Work Order ID 149064

DART SERVICE INSTRUCTION

**TO AMEND IIN-D139-816 REV. D OR SUBSEQUENT
AND ICA-D139-816 REV. 3 OR SUBSEQUENT**

The purpose of this Dart Service Instruction (DSI) is to provide instructions to install the D5078-1 Bracket to support the Overhead Connector for D139-811-011 Interior Ceiling Panel Kit.

Figure 1. - LH Side Overhead Panel

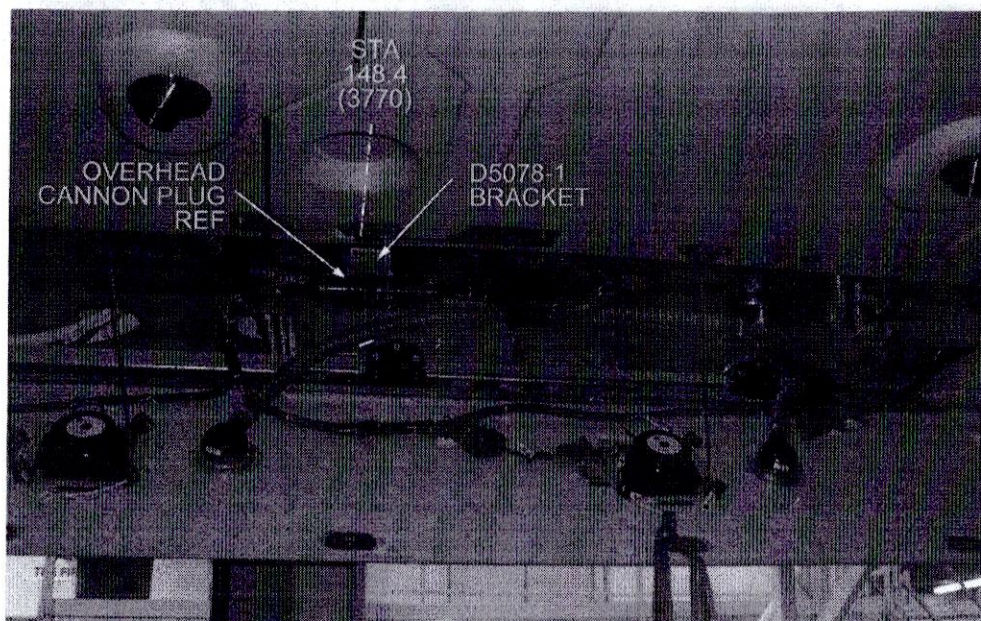
- 2.1 Position the D5078-1 Bracket on the LH side of the cabin overhead by temporarily removing 2x MS27039-1 screws as shown in Figure 1. Transfer 2x $\varnothing 0.204$ " (#6 drill) holes from airframe to the D5078-1 Bracket. Deburr and touch-up holes with MIL-P-85582 or MIL-P-23377 primer.
- 2.2 Install D5078-1 Bracket using existing 2x MS27039-1 screws and washers as shown in Figure 1.
- 2.3 Install overhead cannon plug in the D5078-1 Bracket using existing NAS1801/1802 screws and existing AS85049/95-20A-A Perimeter Mounting Flange as shown in Figure 2.
- 2.4 Reconnect wire harness to overhead cannon plug as shown in Figure 2.
